MIL-PRF-19500/454K
w/AMENDMENT 1
8 July 2024
SUPERSEDING
MIL-PRF-19500/454K
28 February 2019

PERFORMANCE SPECIFICATION SHEET

SEMICONDUCTOR DEVICE, TRANSISTOR, NPN, SILICON, POWER
TYPES 2N5660, 2N5660U3, 2N5661, 2N5661U3, 2N5662, AND 2N5663, JAN, JANTX, AND JANTXV

* FIGURE 1. Physical dimensions, 2N5660 and 2N5661, (similar to TO-66).

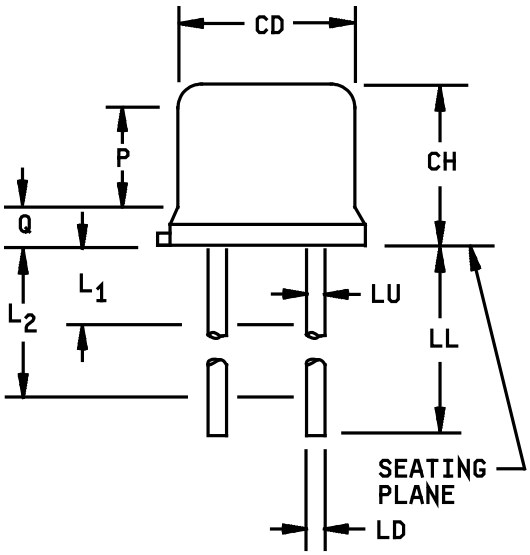
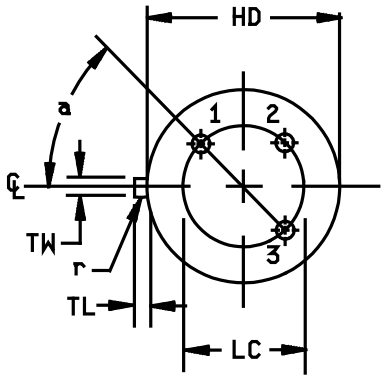
NOTES:
1. Dimensions are in inches.
2. Millimeters are given for general information only.
3. These dimensions should be measured at points .050 inch (1.27 mm) +.005 inch (0.13 mm) -.000 inch (0.00 mm) below seating plane. When gauge is not used, measurement will be made at the seating plane.
4. Two places.
5. The seating plane of the header shall be flat within .001 inch (0.03 mm) concave to .004 inch (0.10 mm) convex inside a .930 inch (23.62 mm) diameter circle on the center of the header and flat within .001 inch (0.03 mm) concave to .006 inch (0.15 mm) convex overall.
6. Lead diameter shall not exceed twice LD within L_1.
7. Body contour is optional within zone defined by CD.
8 Lead 1 is emitter, lead 2 is base, and case is collector.

FIGURE 2. Physical dimensions, 2N5662 and 2N5663, (similar to TO-5).

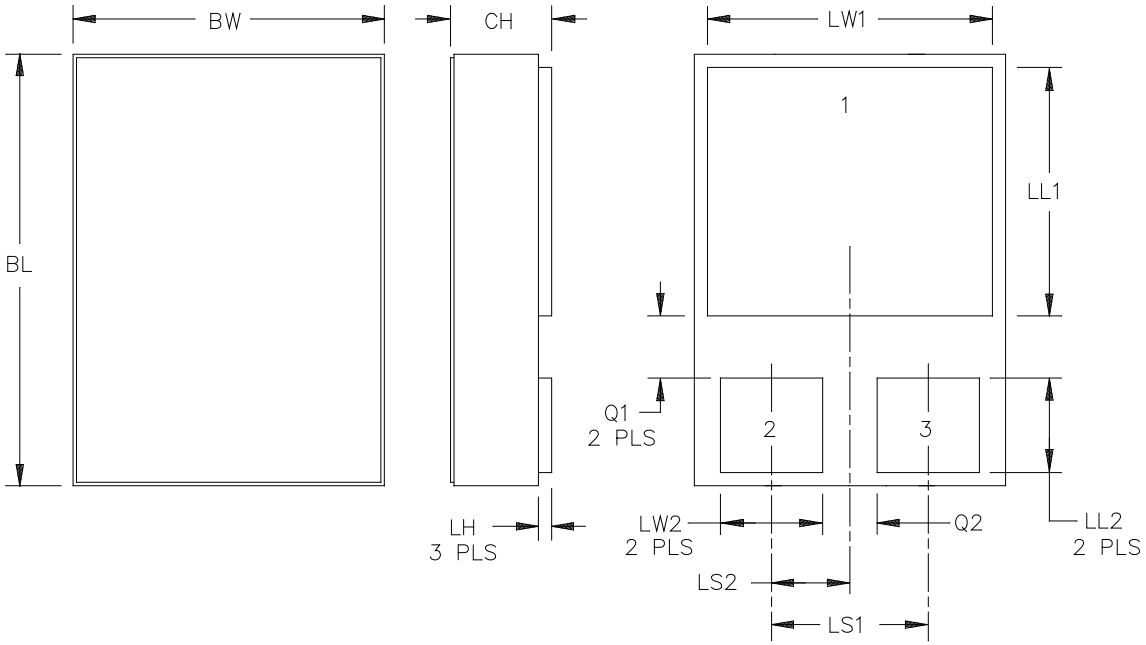
NOTES:
1. Dimensions are in inches.
2. Millimeters are given for general information only.
3. Symbol TL is measured from HD maximum.
4. Details of outline in this zone are optional.
5. Symbol CD shall not vary more than .010 inch (0.25 mm) in zone P. This zone is controlled for automatic handling.
6. Leads at gauge plane .054 inch (1.37 mm) +.001 inch (0.03 mm) - .000 inch (0.00 mm) below seating plane shall be within .007 inch (0.18 mm) radius of TP relative to tab. Device may be measured by direct methods or by gauge.
7. Symbol LU applies between L_1 and L_2. Dimension LD applies between L_2 and LL minimum.
8. Lead number three is electrically connected to case.
9. Beyond r maximum, TW shall be held for a minimum length of .011 inch (0.28 mm).
10. Symbol r is applied to both inside corners of tab.
* 11. Lead 1 is emitter, lead 2 is base, and lead 3 is collector.
